## Product Change Notice (PCN)

**PCN Number:** PCN-0381131R-01

- CLS0501M
- CLS0501M-L152

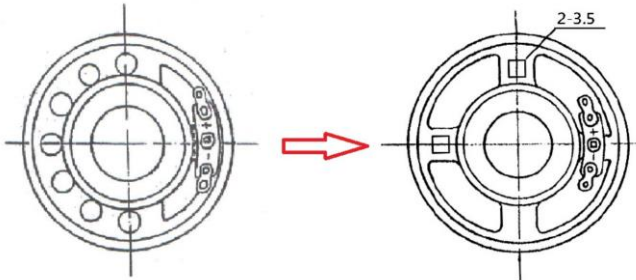
- SPL increased from 80dB to 84dB
- Frame shape has changed (Image Below)
